TENNESSEE VALLEY AUTHORITY

WATTS BAR NUCLEAR PLANT UNITS 1 AND 2 - RESPONSE TO NRC REGION II INSPECTION  
REPORT 50-390/84-71 AND 50-391/84-47

**ENCLOSURE**

Figure 1. Daytime Wind Roses for the 46m and 10m levels of the Watts Bar Meteorological Facility, based on January 1, 1981 - December 31, 1983 data.

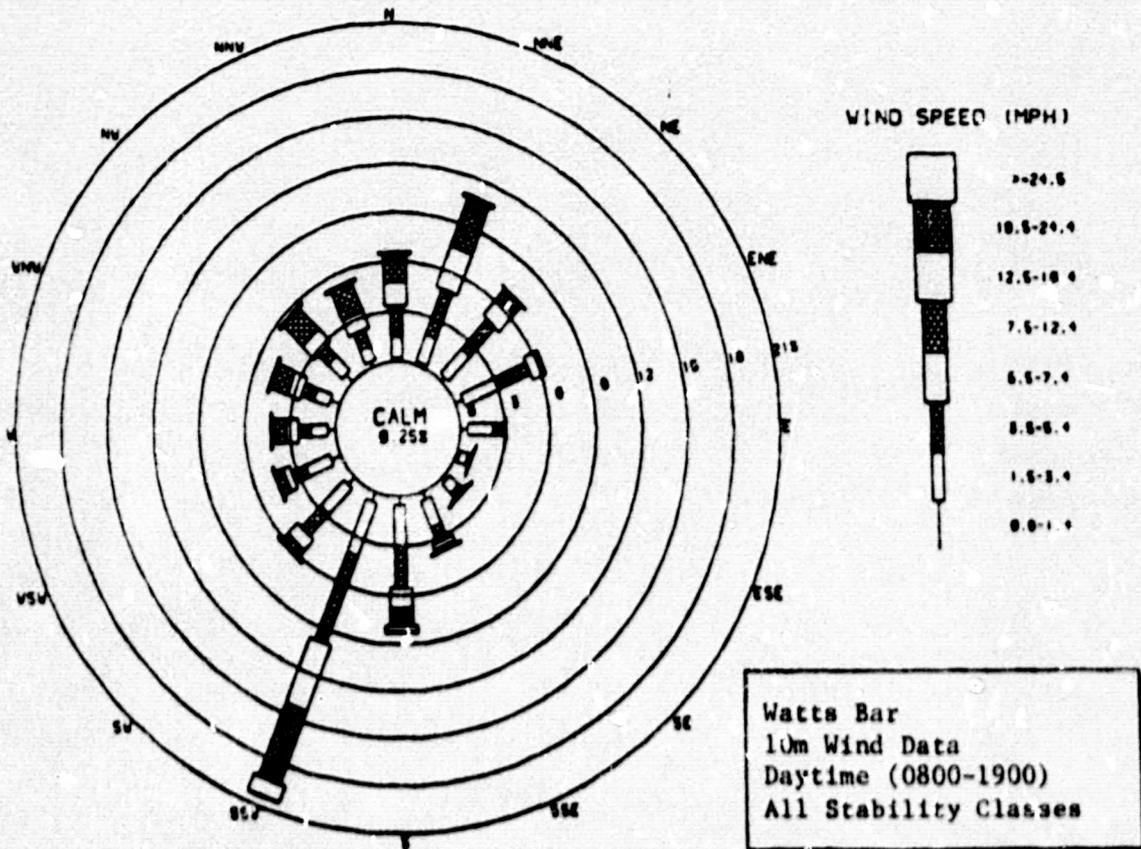
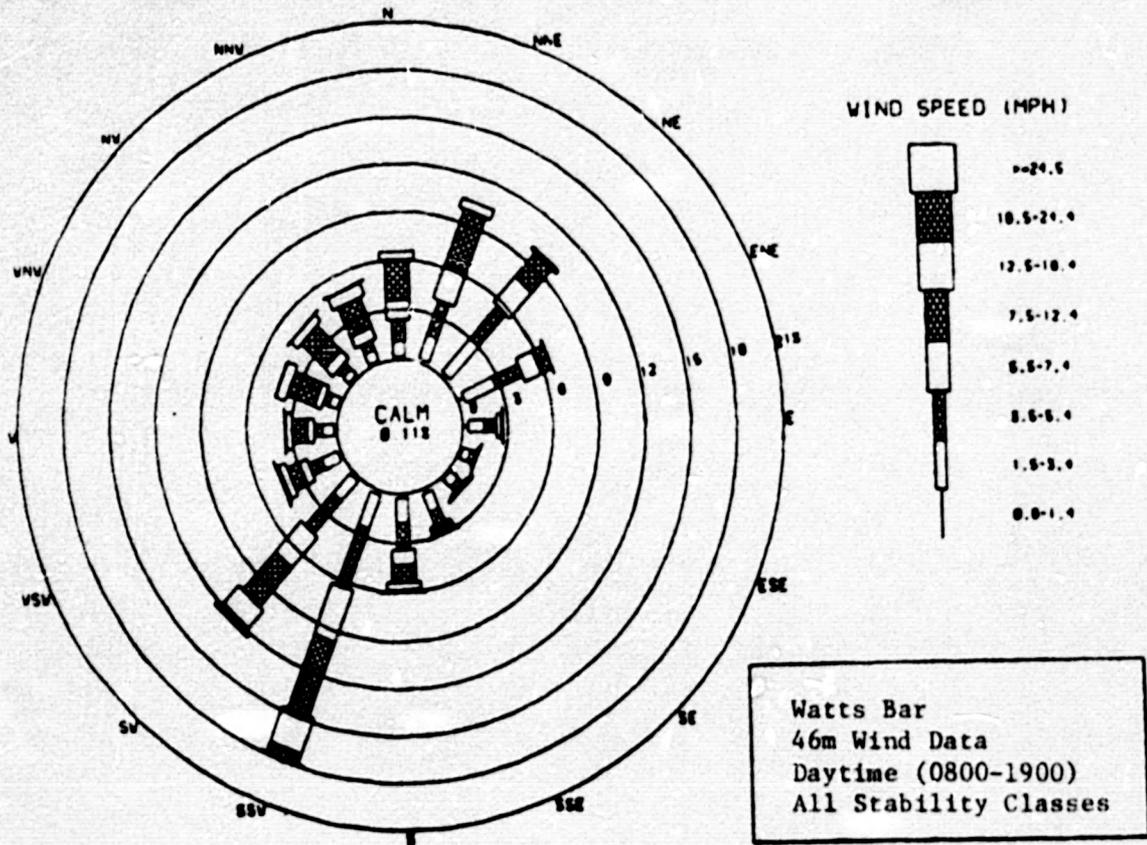
- c. The use of 46m wind speed and direction information in lieu of 10m information should be substantiated.

TVA has elected to use 46m wind data in lieu of 10m wind data in emergency preparedness procedures. Use of the 46m data is expected to result in better estimates of plume transport in the Watts Bar Nuclear Plant area by avoiding local influences which are reflected in the 10m wind data.

In figure 1, daytime wind roses for both levels (based on January 1, 1981-December 31, 1983 onsite data) are noted to be quite similar. The most noticeable difference is a higher

frequency of southwest winds at the 46m level. Mean daytime wind speeds for the 10m and 46m levels were 5.2 and 6.9 mi/h, respectively.

Figure 2. Nighttime Wind Roses for the 46m and 10m levels of the Watts Bar Meteorological Facility, based on January 1, 1981 - December 31, 1983 data.

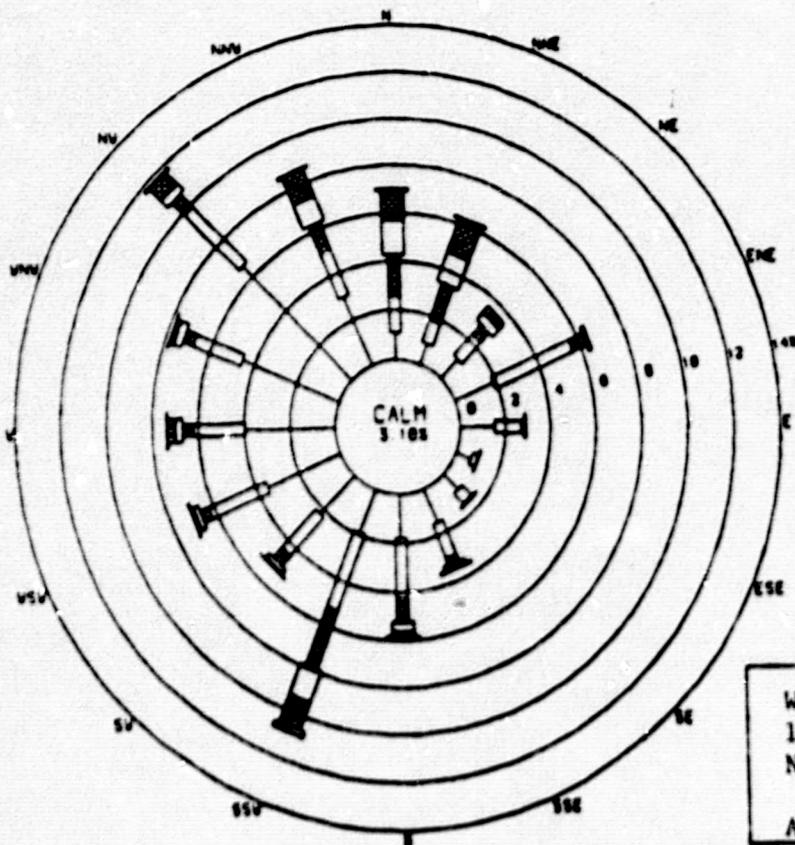
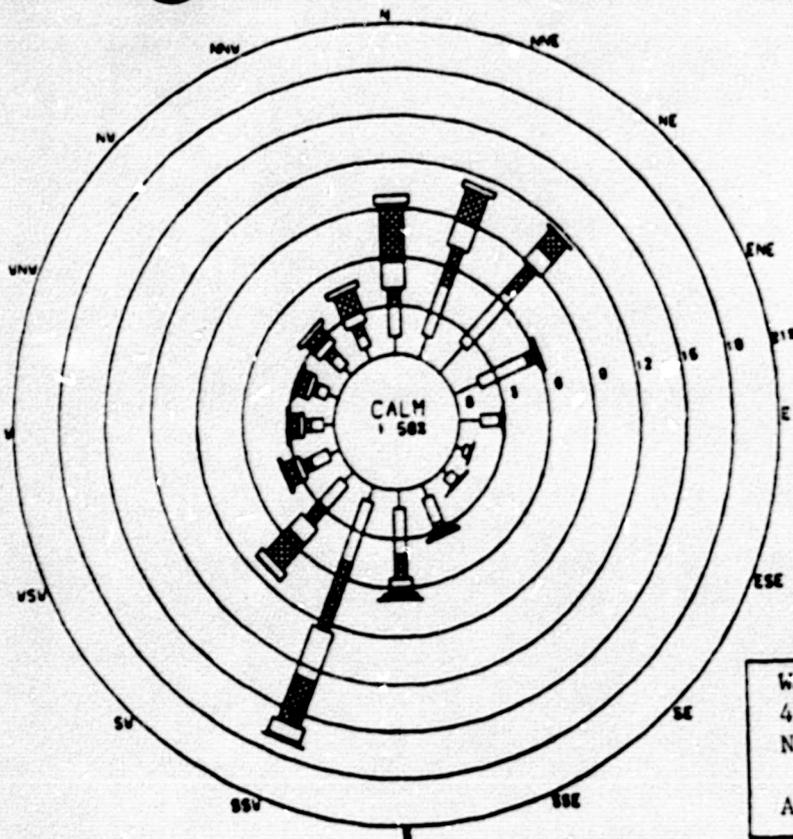
- d. The reference to "local influences" affecting data collection at the 10m level should identify the "local influence."

Figure 2 includes the nighttime wind roses for the two levels (note different scales) for the same data period. A much higher frequency of very light winds from the west-southwest through northwest directions is noted at the 10m level than at the 46m level. These light winds occur most frequently with F or E stability classes, which account for 56 percent of the nighttime stability observations. Airflow from these directions under stable conditions is not expected to persist very far from the plant. Mean nighttime wind speeds for the 10m and 46m levels were 2.9 and 4.8 mi/h, respectively.

The local influence on dispersion of primary concern at Watts Bar is the high frequency of light winds, from the west-southwest through northwest directions, measured at the 10m level but not the 46m level of the meteorological tower under nighttime stable conditions (see figure 2). This influence may result from a flow of cool air downslope from a low northeast-southwest aligned ridge located about 1.5km northwest of the meteorological tower. Under stable conditions, the closest ridge on the opposite side of the river would block these light winds and would tend to divert them, most probably in a downvalley manner. For this reason, the influence is considered to be local.

Figure 3. Plume location based on the following meteorological data:

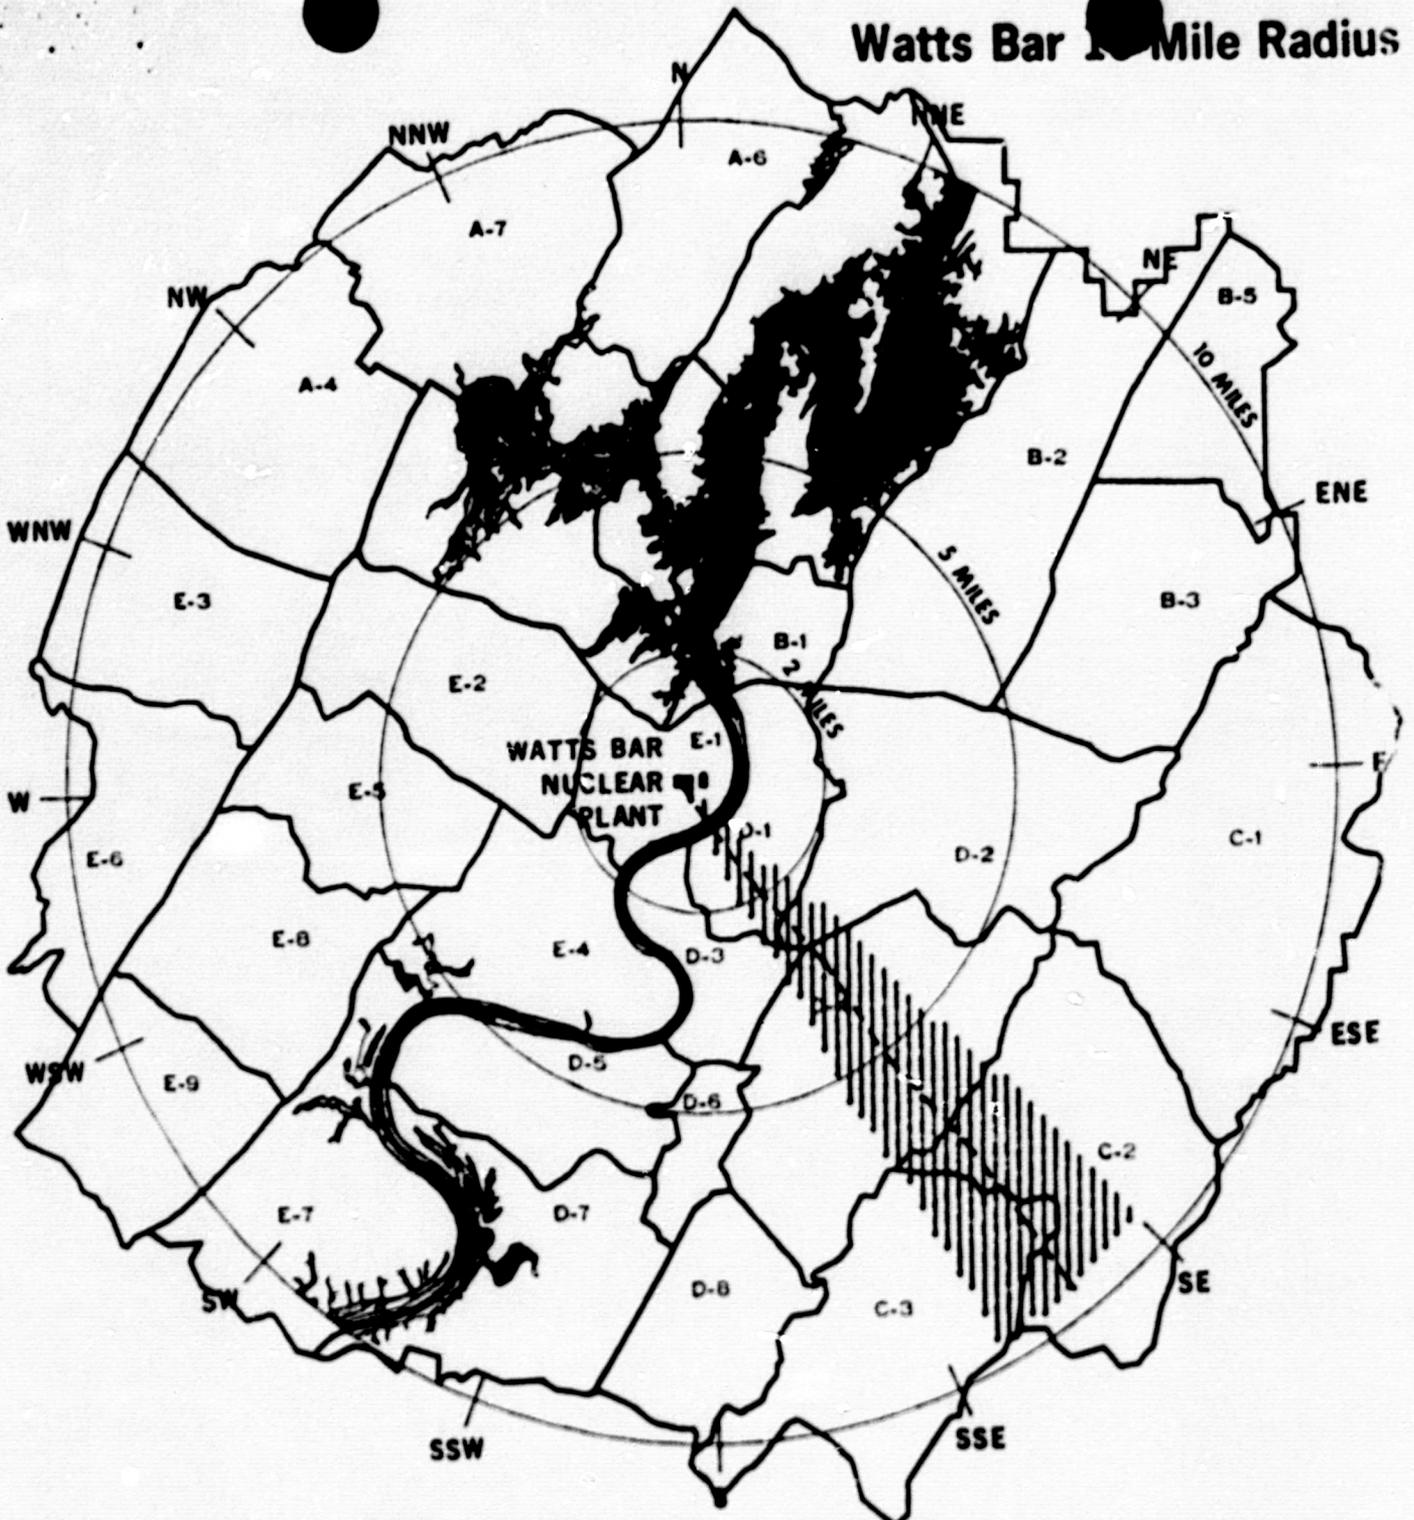
- e. Failure to use 10m data for ground level releases, a deviation from standard procedures, should be justified.

Figures 3 and 4 are plume plots based on onsite data for 2100 on January 21 through 0400 on January 22, 1984. The 10m plot (figure 3) shows the plume apparently moving over the higher terrain to the southeast. This plot shows the effect of the local influence, discussed in question d. above, on the model calculations. The 46m plot in figure 4 gives a more realistic indication of potential plume transport under these conditions.
